DESIGN REVIEW COMMITTEE

May 21, 2025 6:00 PM

DATE: May 12, 2025
TO: Tonya Hutson
FROM: Lynn Patterson
RE: **Design Review – 558 Woodrow Ave Window Changes**

DATE: May 12, 2025
 TO: Tonya Hutson
 FROM: Lynn Patterson
 RE: **Design Review – 3166 Dogwood Drive Revisions May 2025**

2 SOUTH ELEVATION (REAR)
SCALE: 1/4" = 1'-0"
GRAPHIC SCALE

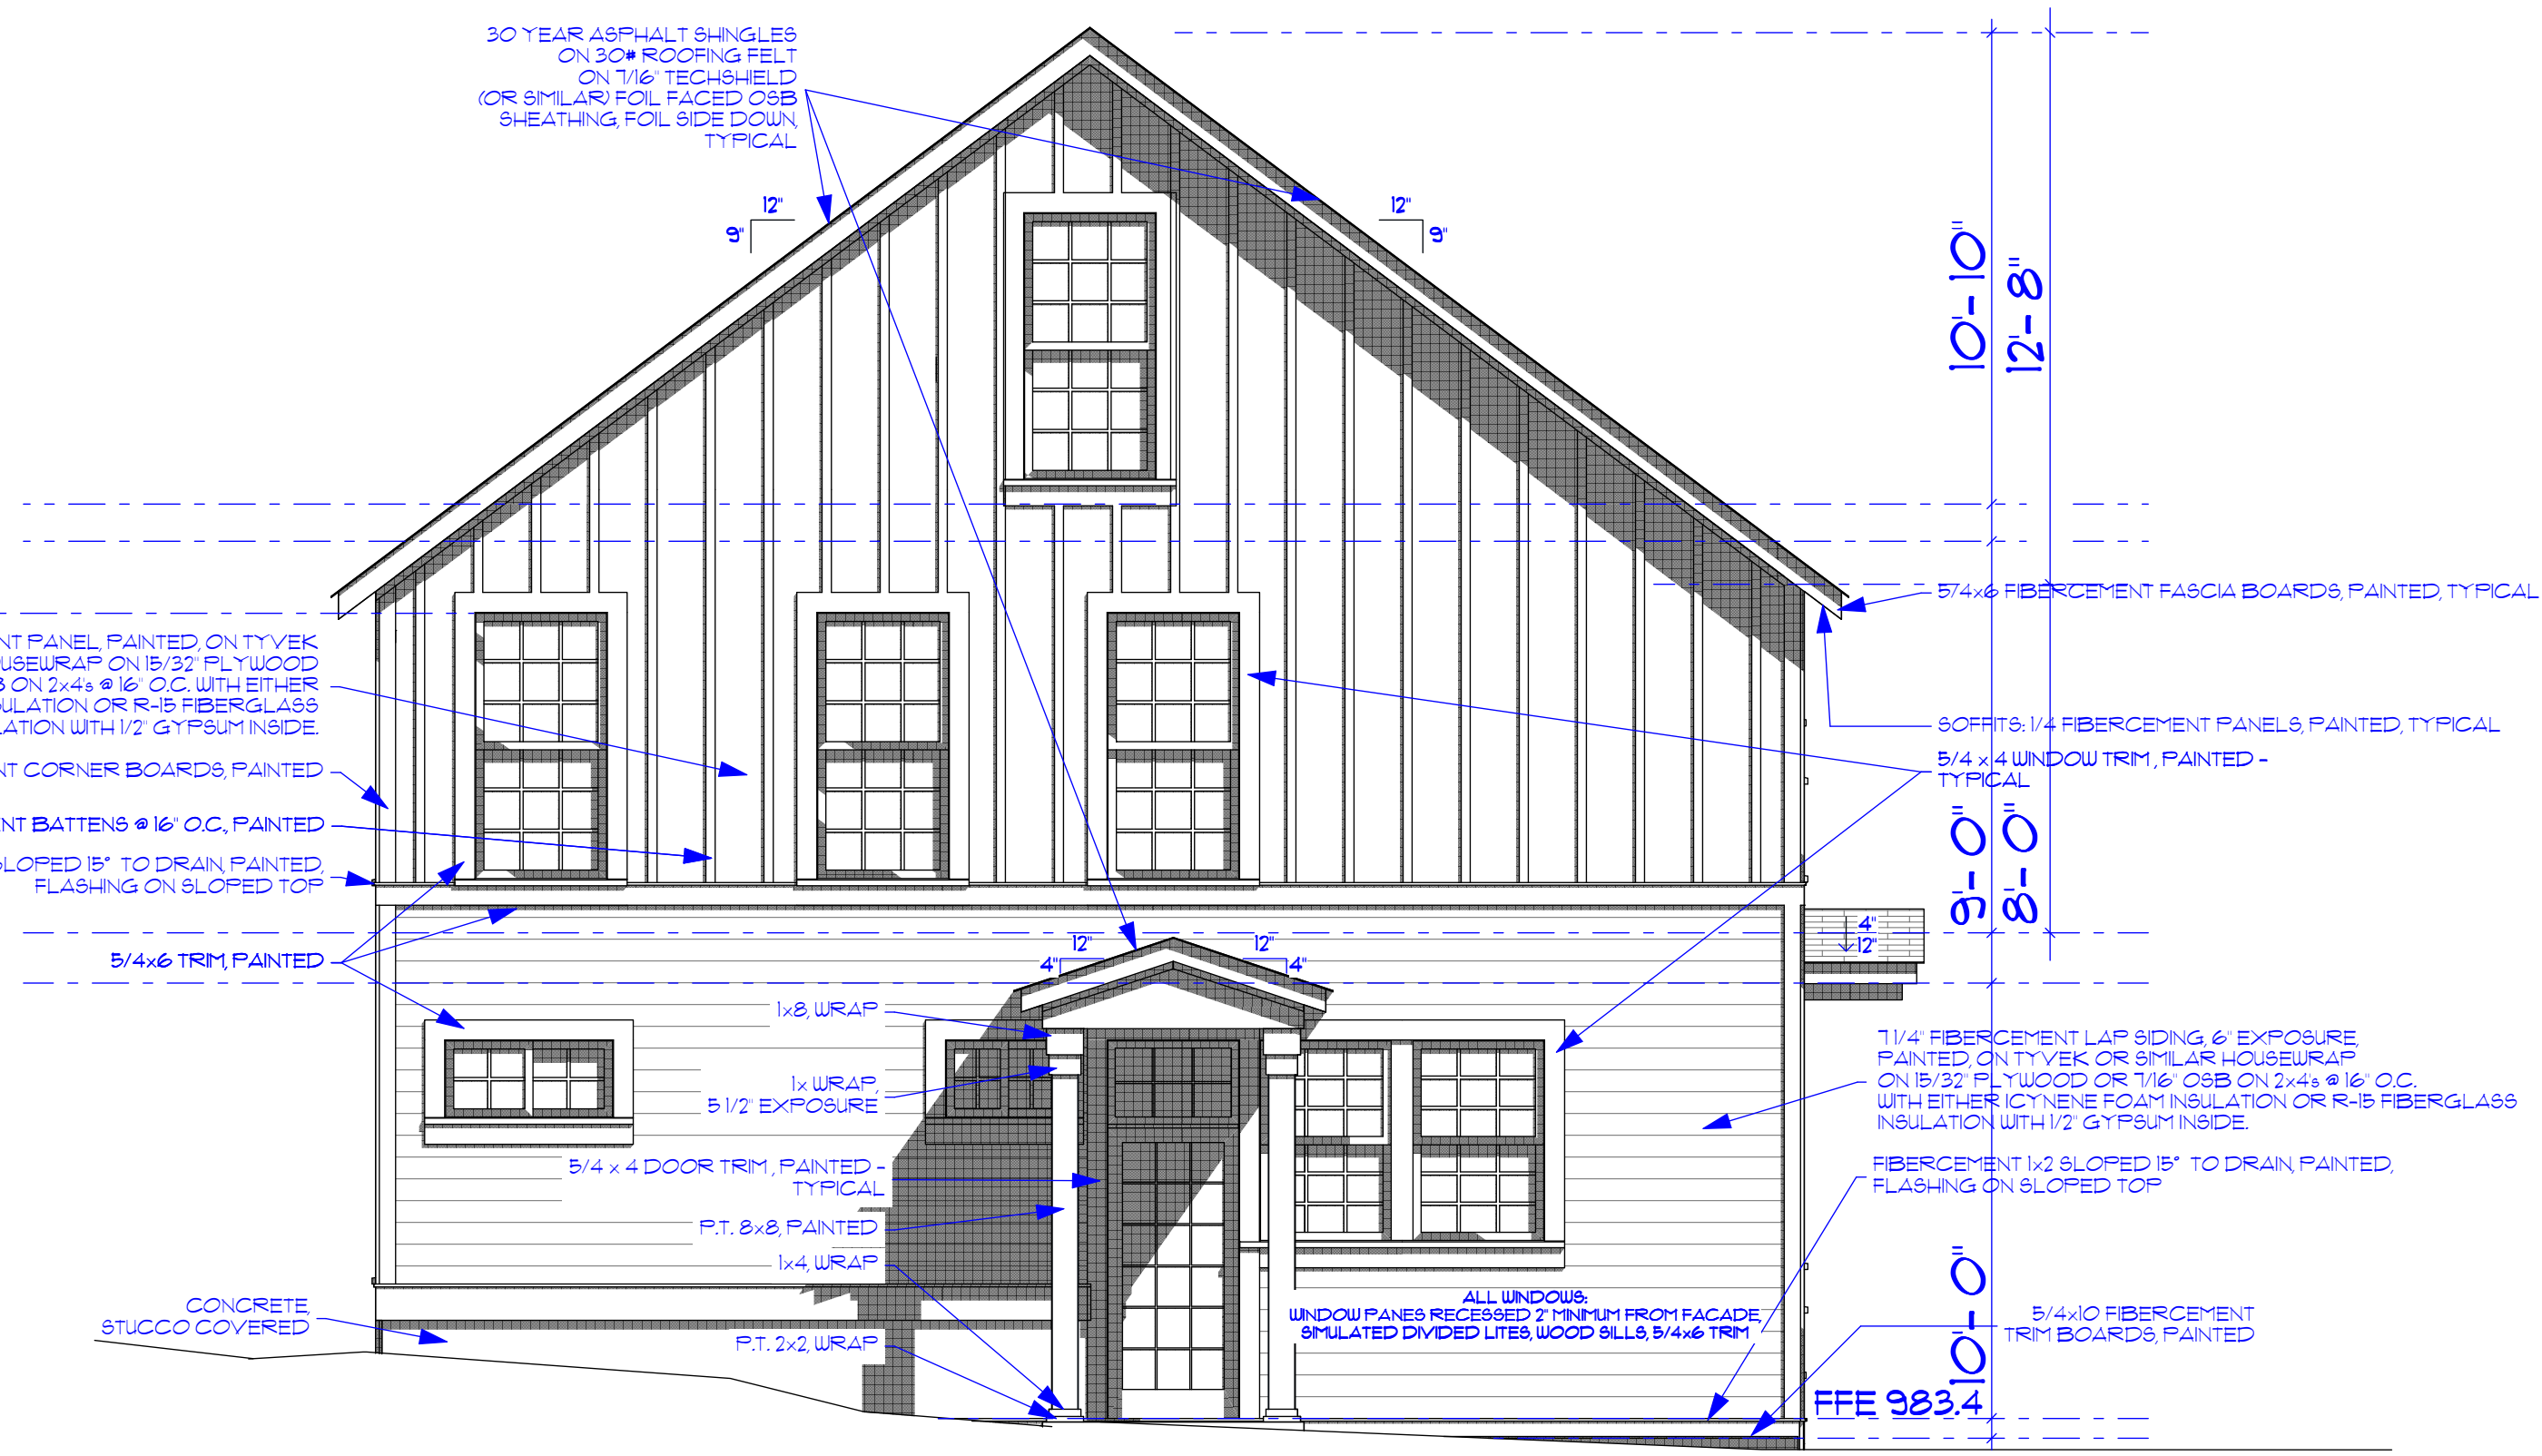
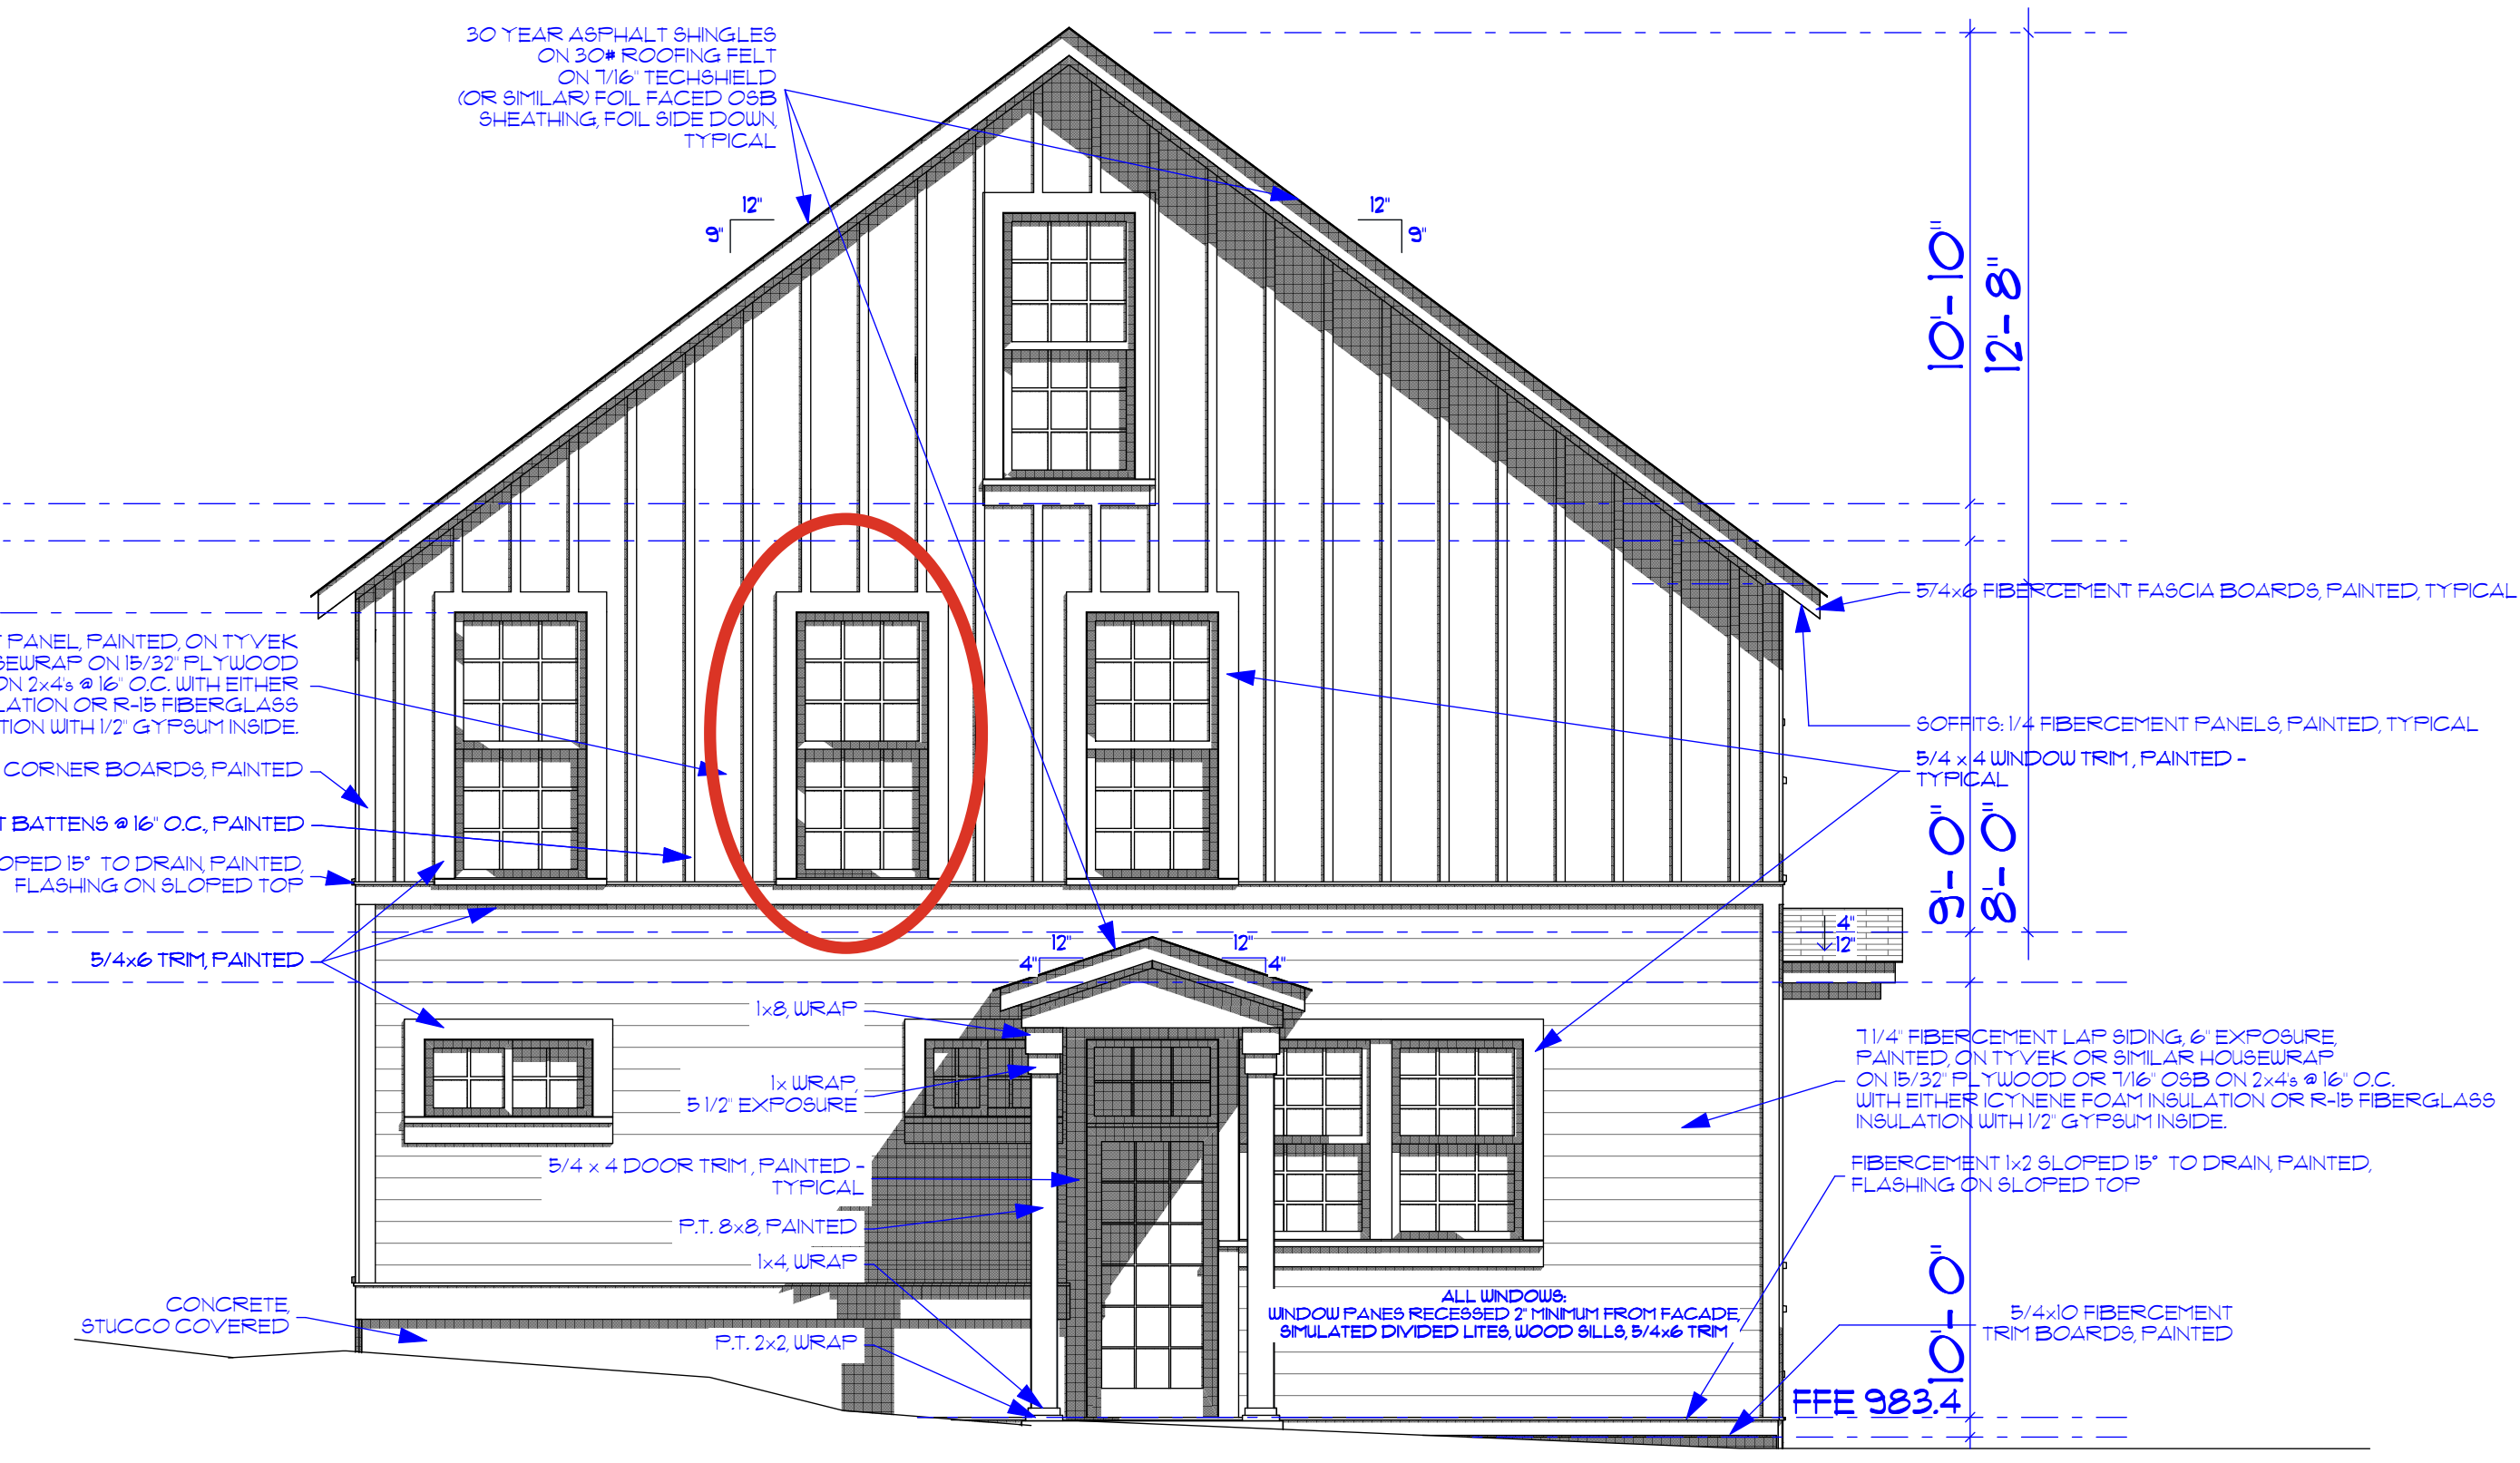
(1) 2A-1: South Elevation (rear)

- a. Second window is replaced with a small sliding window to maintain bathroom privacy. Full length window is replaced. Mistake by architect in placing full length window in bathroom. Window is now replaced.

The deletion of the windows does not negatively impact required fenestration percentages and the impacted windows are located at or toward the rear of the dwelling, which limits the visibility from the public right of way.

(2) 2A-4: East Elevation (left)

- a. Far left window is removed to fit gas stove hood. Stove placement inside the kitchen is in the southeast and window placement by the architect was not correct to accommodate this. Contractor removed window for stove and hood placement. Window is now removed.

FRONT ELEVATION

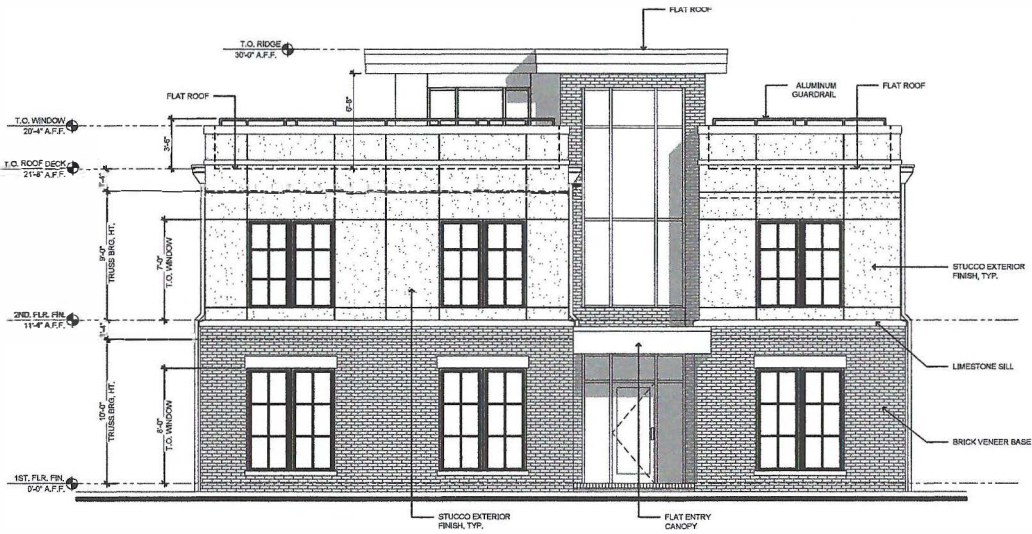
1. An upper roof with the same parapet detail as the lower roof.
2. The curtainwall above the front entry extends above the lower roof.
3. The upper roof is wrapped by windows on the left-side

1. The upper roof has been eliminated, and parapet detail extends across the front façade, except where the brick is shown.
2. The aluminum guardrail extends along the entire parapet.
3. The top of the curtainwall above the front entry has been lowered to just below the second-floor ceiling.

REAR ELEVATION

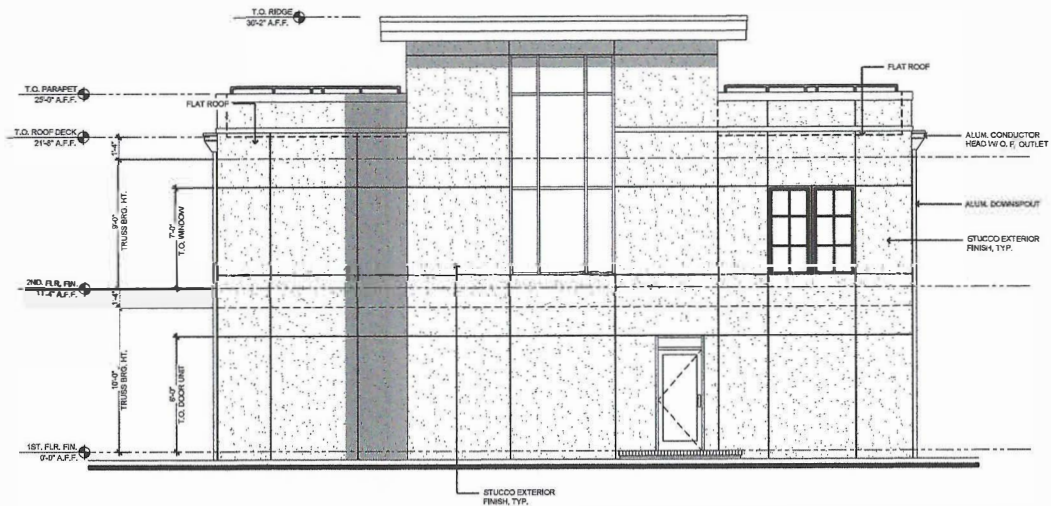
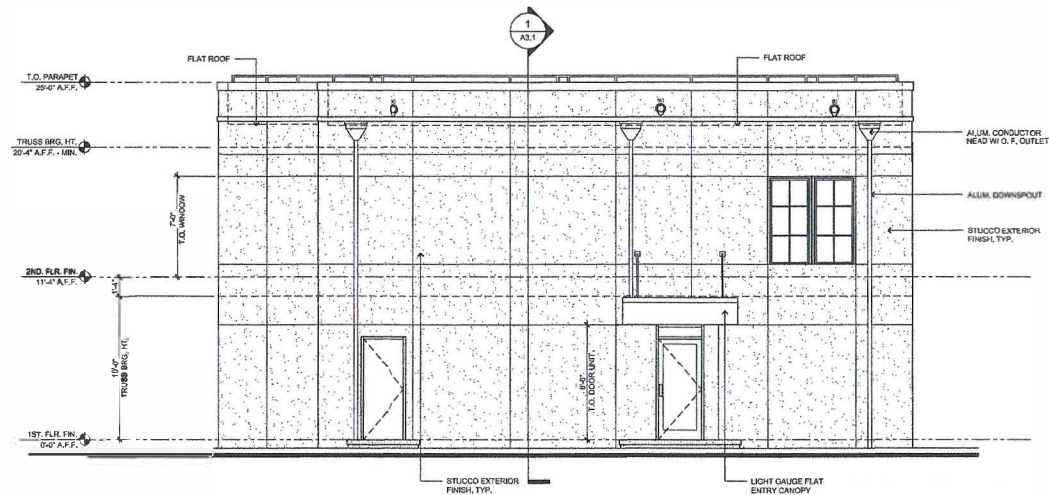
1. An upper roof with the same parapet detail as the lower roof.
2. A large section of window that extends from the top of the first floor to just below the upper roof parapet.

1. The upper roof and parapet have been eliminated.
2. The large section of window that extends from the top of the first floor to just below the upper roof parapet has been eliminated.
3. Three scuppers and three downspouts have been added.
4. Three roof over-flow drains have been added.
5. A rear door for an exterior storage closet has been added.
6. A canopy has been added to the staff entry door.
